STIP 608

RE: Investigation / Remediation Related to the Former Underground Storage Tanks at Dunne Quality Paints, 1007 41st Street, Oakland, California.

In response to your letter to Terry Turner, dated June 30, 1993, the following clarifications are hereby presented:

FIGURE 1.
Well Construction.

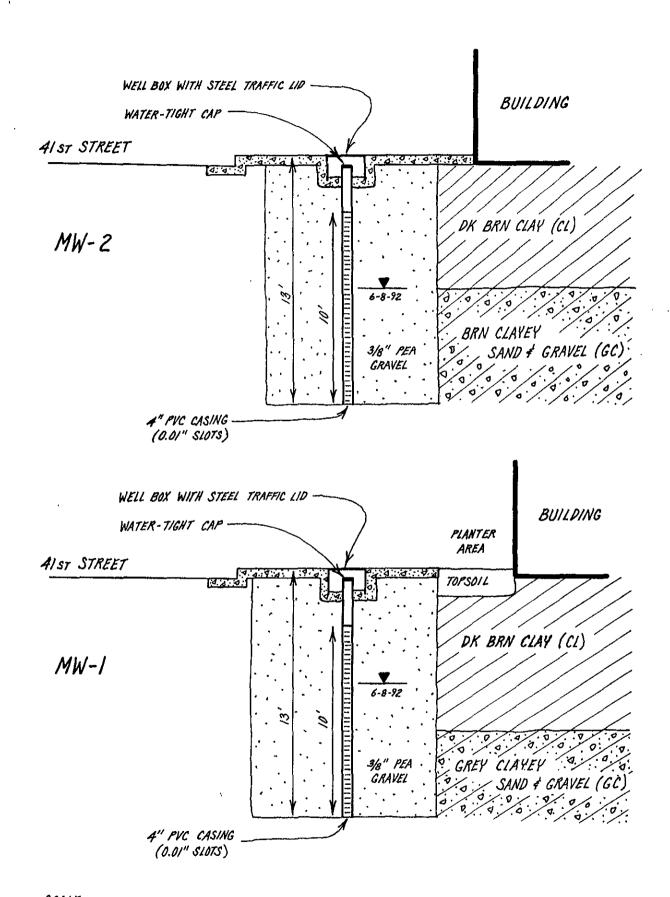
- 4) Monitoring Well Construction. The two on-site shallow groundwater monitoring wells were constructed by SEMCO. Upon completion of the soil excavation, two 4-inch well casings were suspended inside the excavation, with the bottoms resting on the bottom of the excavation. Each well casing consisted of 10 feet of 4-inch PVC slotted screen pipe (0.01" slots), and were each completed up to the ground surface with 4-inch PVC blank casing. The total depth of each well is 13 feet below ground surface. The excavation was subsequently backfilled around each well casing with 3/8" pea gravel.

The well construction is illustrated on Figure 1. As shown by this figure, each of the monitoring wells MW-1 and MW-2 is screened to intercept free floating product and to accommodate water table fluctuations. It would appear that the samples collected from these two monitoring wells are representative of the shallow groundwater quality in the immediate vicinity of the

FIGURE 2. Shallow Groundwater Table Contour Map. (June 18, 1992)

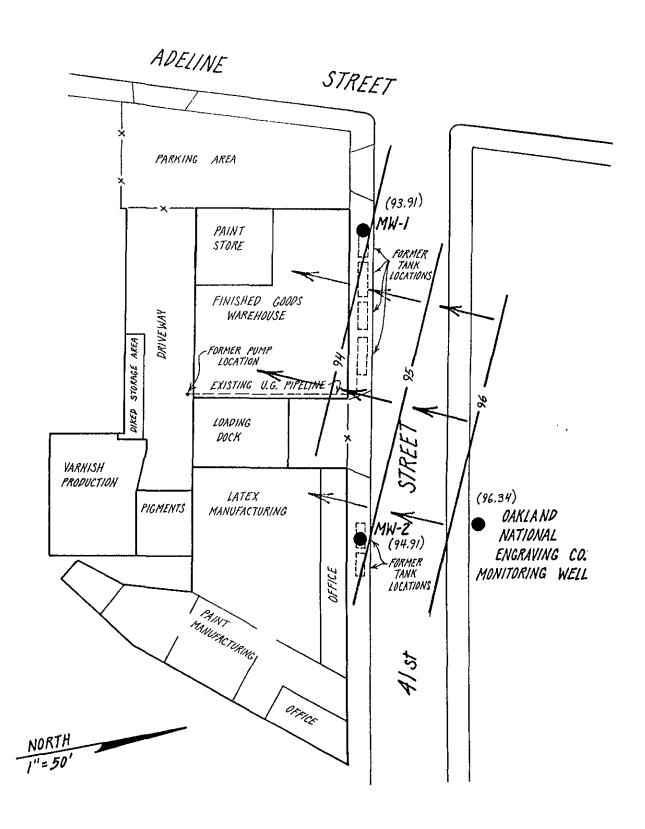
Groundwater Flow Direction. Shallow water table elevations were measured on June 18, 1992. These measurements are shown in Table 1. The top-of-casing elevations were surveyed by Hageman-Aguiar, Inc., with the top-of-casing elevation of well MW-1 arbitrarily set at 100.00 feet. In addition to the two on-site monitoring wells, the one shallow groundwater monitoring well installed by Oakland National Engraving Company on the opposite side of 41st Street was also surveyed and a single depth-to-water measurement was collected. The field work on the Oakland National Engraving property was conducted in the presence of Gary D. Leach, vice president/CFO.

Figure 2 presents a contour map for the shallow groundwater table beneath the site (June 18, 1992). As shown in this figure, the data from these monitoring wells indicate that the shallow groundwater flow beneath the site is calculated as being in a southwesterly direction.

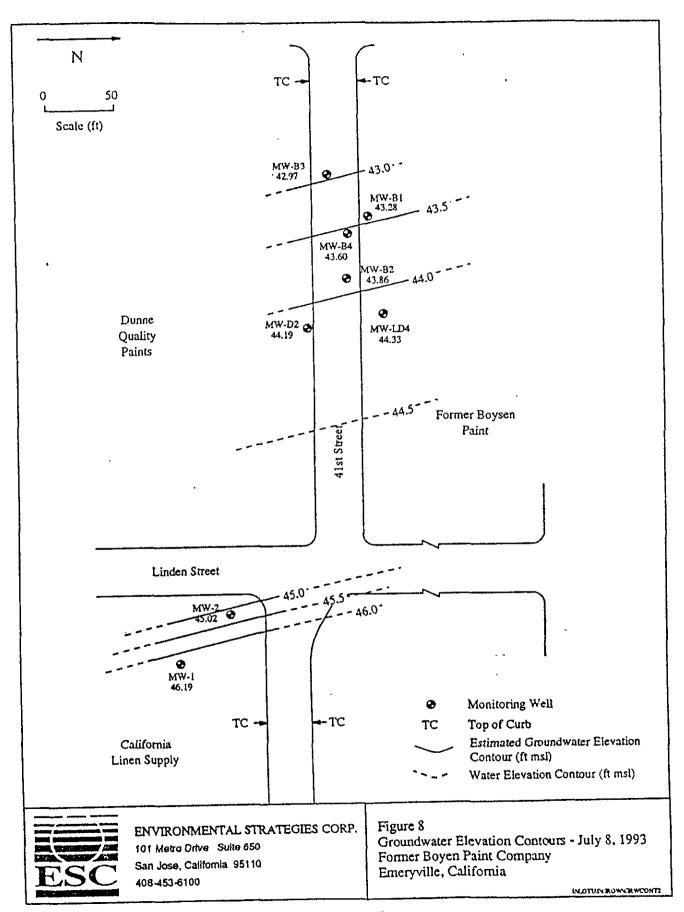
groundwater elevations have been made available by the work conducted by Environmental Strategies Corporation at the Former Boysen Paint Company. The contour map for the shallow groundwater table on July 8, 1993, in the vicinity of the former Dunne Paint site is shown on Figure 3. As shown in this figure, the data indicate that the shallow groundwater flow is calculated as being in a west-southwesterly direction.

Based upon the data presented above, <u>it would appear that</u> a verified down-gradient direction has been established for the former Dunne Paint site.
